DAIMLERCHRYSLER

Service Measure – Replace hose clamp on steering return hose, Model 163

Work Instructions

Replace clamp on power steering hose

Illustrated on Model 163.154

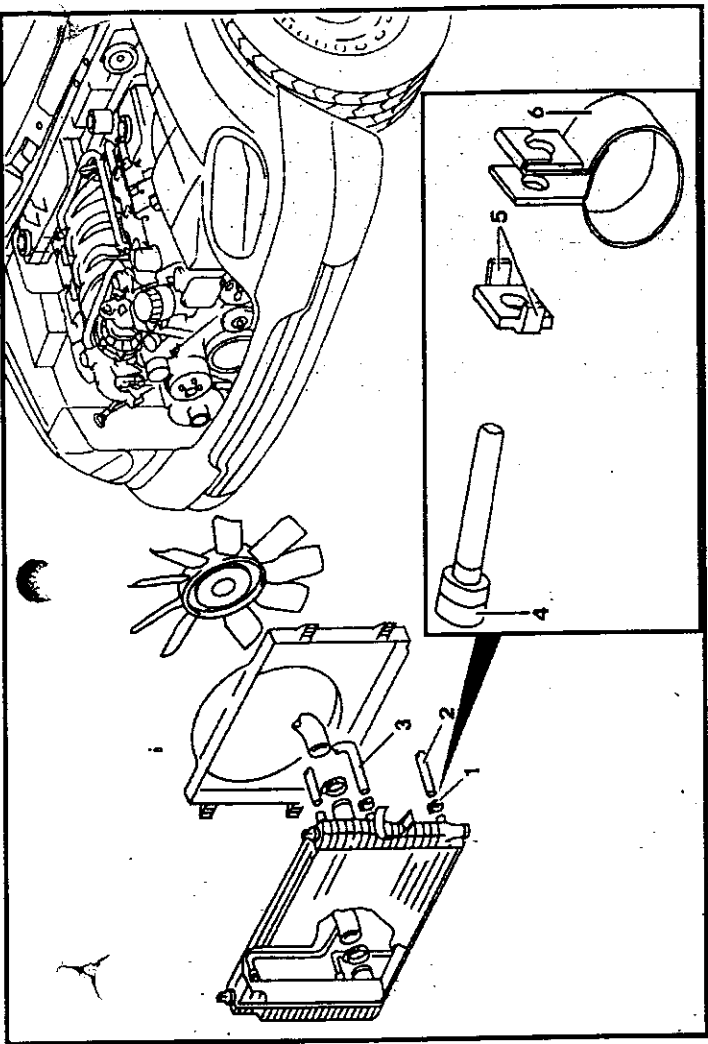
- 1 Clamp
- 2 Lower steering hose (steering gear → radiator)
- 3 Upper steering hose (radiator → expansion reservoir of power steering pump)
- 4 Screw
- 5 Anti-rotation tab
- 6 Clamp, replacement

- 1. Place vehicle on lift.
 - i Model 163.113 only **WIS Document: AR00.60-P-1000GH**
- 2. Turn off engine and remove ignition key.
- 3. Open hood.
- 4. Clamp upper (3) and lower (2) power steering hoses using specified hose clamping tools.
 - i 000 589 40 37 00
- 5. Remove front section of noise encapsulation.
 - i Model 163.113 only **WIS Document: AR94.30-P-5400GH**
- 6. Loosen existing lower clamp (1) and slide clamp down hose away from radiator fitting.
 - i DO NOT detach or disturb hose in order to prevent fluid loss.
- 7. Inspect condition of lower steering hose (2).
 - i Hose should NOT be replaced unless outer casing exhibits cuts or splits.

- 4 Screw
- 5 Anti-rotation tab
- 6 Clamp, replacement

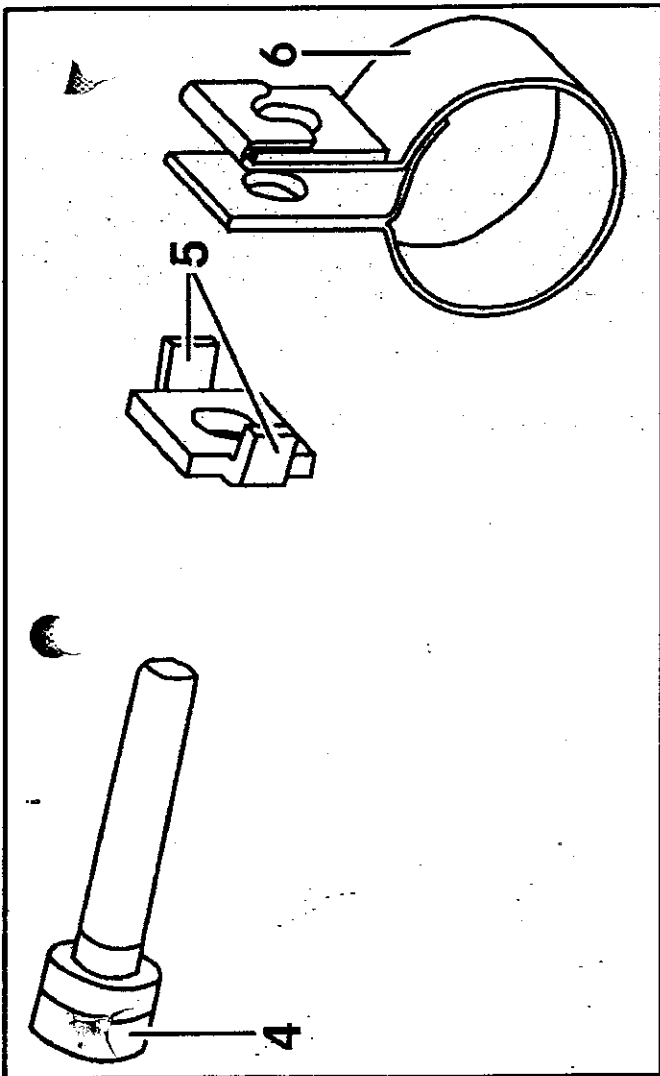
8. Open replacement clamp (6) to fit over lower steering hose (2).
 - p Do not open clamp more than just enough to fit over hose, or clamp may be damaged.

- i New clamp **MUST** have "Nr St 15" stamped on outer surface. Other hose clamps must **not** be used.
9. Secure replacement clamp (6) in proper position around lower steering hose (2) and tighten screw (4).

- p Observe proper torque specification! Ensure proper orientation of anti-rotation tabs (5).
 - n 2.0 +0.5 / -0
 - i Do not exceed torque value, even if hose can still be rotated on fitting.

10. Open previous clamp (1) sufficiently to remove from around lower steering hose (2).
 - i Discard clamp (1).
11. Remove specified hose clamping tools from upper (3) and lower (2) power steering hoses.

- t 000 589 40 37 00
12. Start vehicle and check for leakage at connection.
13. Reinstall front section of noise encapsulation.
 - i Model 163.113 only
